CHANGE ORDER

DATE OF ISSUANCE 1/28/2019 EFFECTIVE DATE 1/28/2019 No. 2

PROJECT: 2018 Water System Improvements

Change Order 2 – Fire Line to 824 Center Street

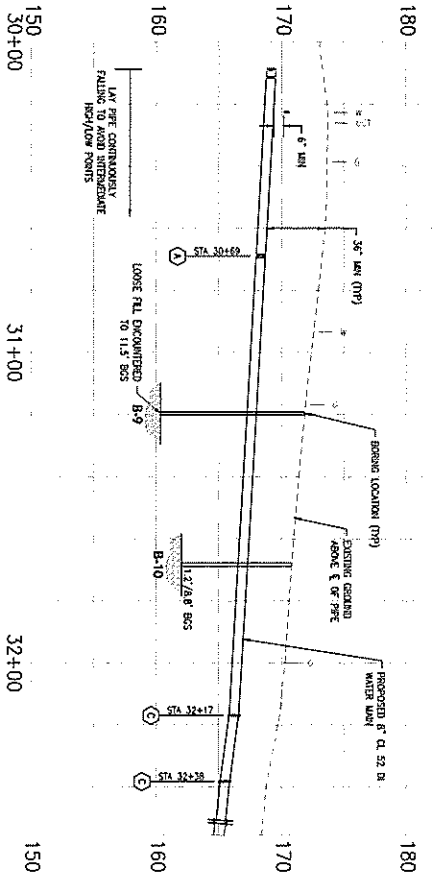
Description: Furnish and install all materials, equipment and labor necessary to construct a new fire line to 824 Center Street as detailed on the revised sheet C7 dated 1/25/2019.

Reason for Change Order: During installation of the waterline on 9th Street, an existing unknown fire line to 824 Center Street was discovered. The City determined that this fire line needed to be reconnected as part of this project to ensure the continuing functionality of any fire systems inside the building.

Rock ex to be paid per Chris' measurements. Profile view in new drawing still shows rock below pipe zone. (Probably not the case)

Following up regarding the fire line encountered on 9th Street serving 824 Center Street. Attached is a revision to sheet C7 that shows what the City would like to do to re-establish this connection. This sketch is the same as what we discussed in the field. Let me know if you see any issues with this approach or if you had something else in mind.
